BUILDING CODE OF AUSTRALIA CONSTRUCTION REVIEW REPORT

PROPOSED RESIDENTIAL UNIT DEVELOPMENT

5-7, 7A & 9 CROYDON STREET, LAKEMBA

REPORT NO. ► 12728_R02 - FINAL

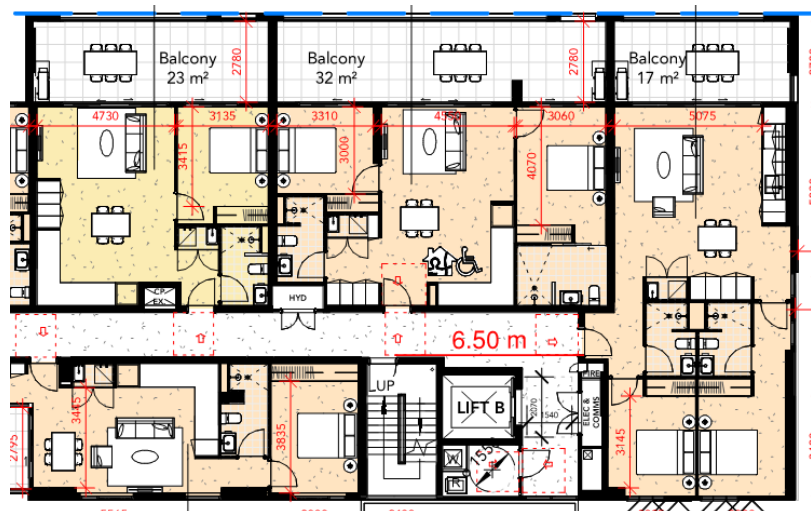
- The travel distance from the south-eastern end of basement 1 exceeds 20 m to a point of choice (measured 20.6 m worst case), which does not comply with part (3)(a) of this clause. The fire engineers have captured this in the revised FEBQ.

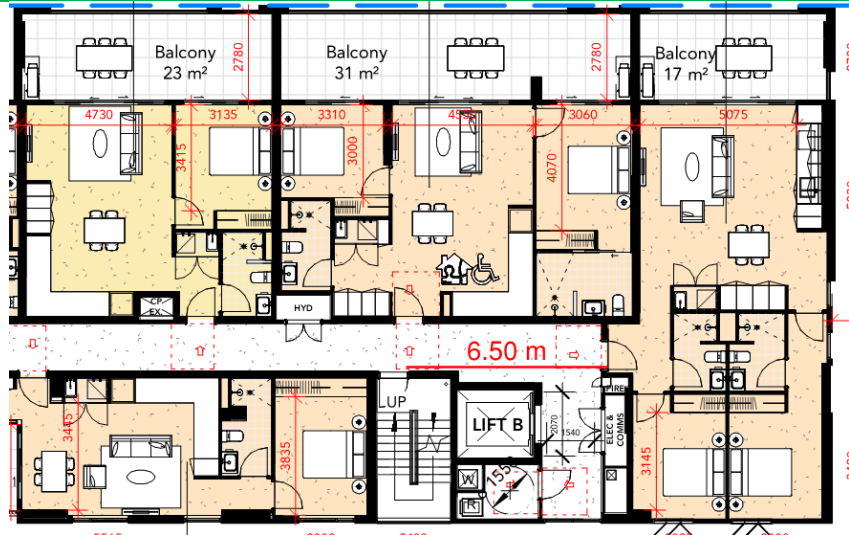
- The travel distance from the SOU doorway located eastern end of Building B, on Levels 2-4, are more than 6 m from a point of choice (measured 6.5 m) which does not comply with part (1)(a)(i) of this clause.

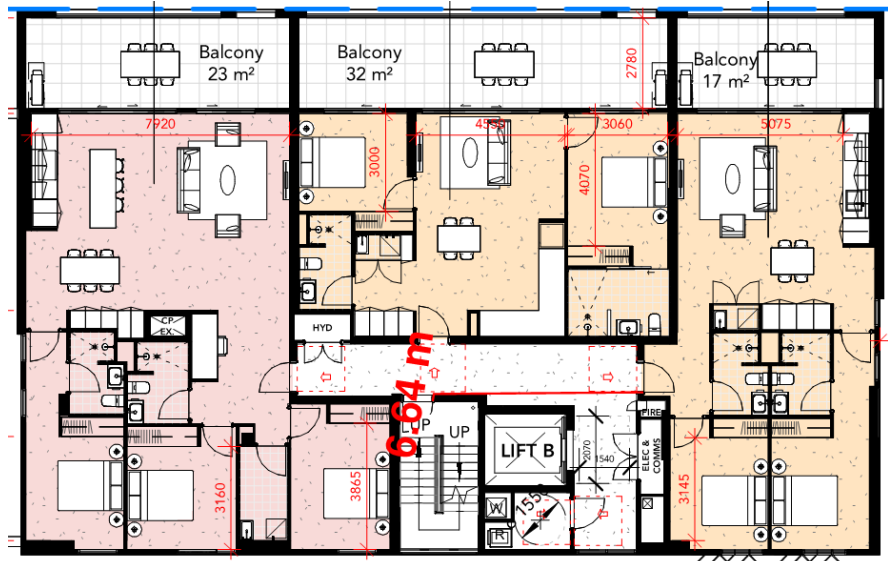
- The travel distance from the SOU doorway located eastern end of Building B, on Level 5 is more than 6 m from a point of choice (measured 6.5 m) which does not comply with part (1)(a)(i) of this clause.

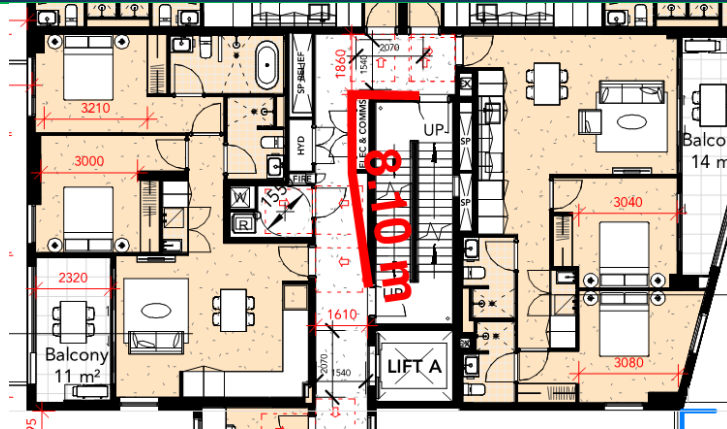
- The travel distance from the SOU doorways (4 units total on each storey) located southern end of Building C, on Levels 2-4, are more than 6 m from a point of choice (measured 8.2 m worst case) which does not comply with part (1)(a)(i) of this clause.

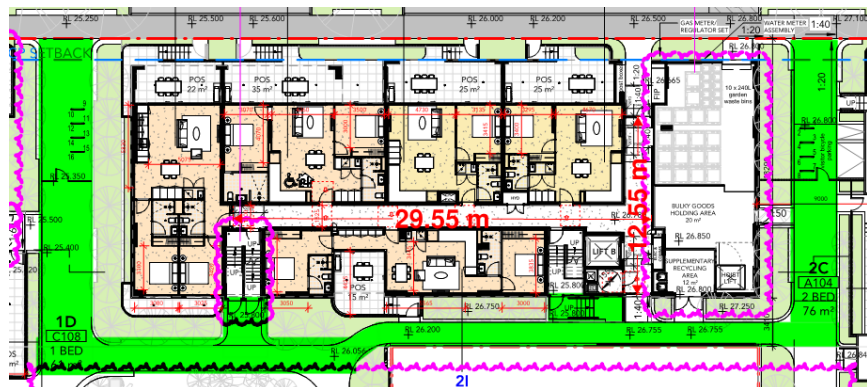
- The distance between alternative exits in Building C, between Levels 2 – 10 is less than 9 m (measured 4.8 m) and does not comply with part (b) of this clause.

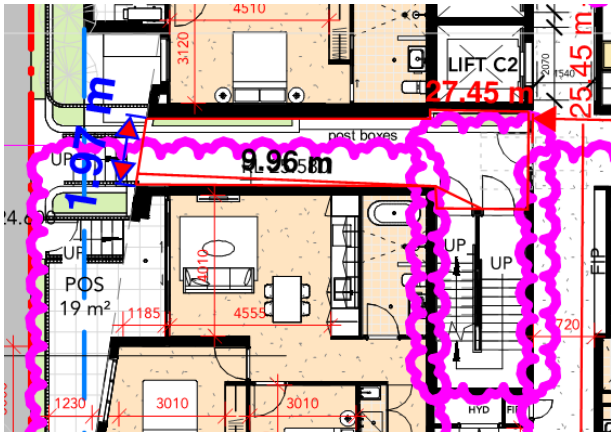
- The path of travel from the discharge point(s) of the fire-isolated stairways serving Building B necessitate passing within 6 m of external walls of the same building and require protection in accordance with part (3) of this clause. Architect to demonstrate compliance with this clause.

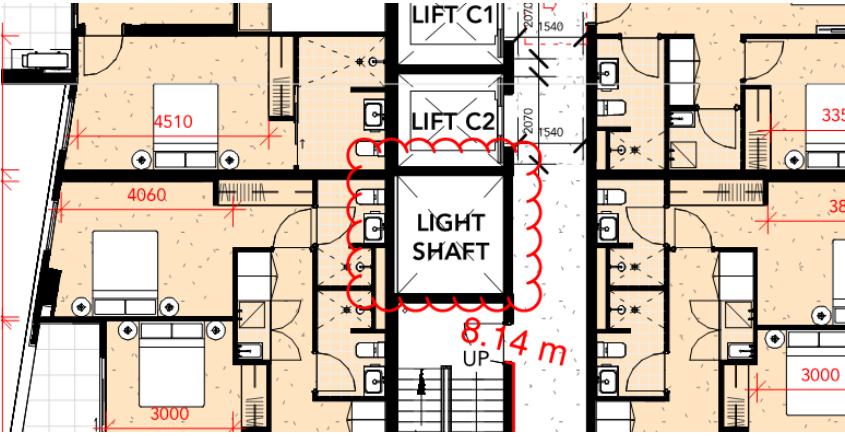
- The path of travel from the discharge point(s) of the fire-isolated stairways serving Building C necessitate passing within 6 m of external walls of the same building and require protection in accordance with part (3) of this clause. Architect to demonstrate compliance with this clause.

Figure 2: Basement 2 Storage Areas

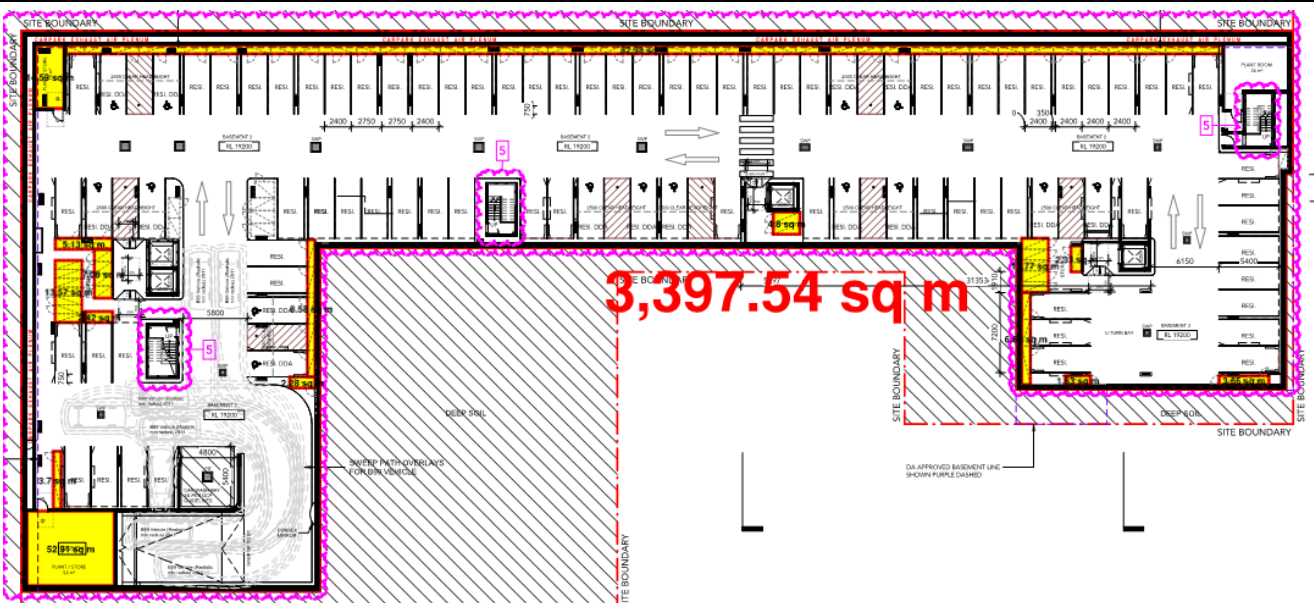
- The storage areas on basement 1 and 2 have been calculated to be less than 10% of the storey and receive concession under A6G1.
- The storage room and managers office on Lower Ground Level in Building A, are each less than 10% of the floor area of the storey and receive concession under A6G1.
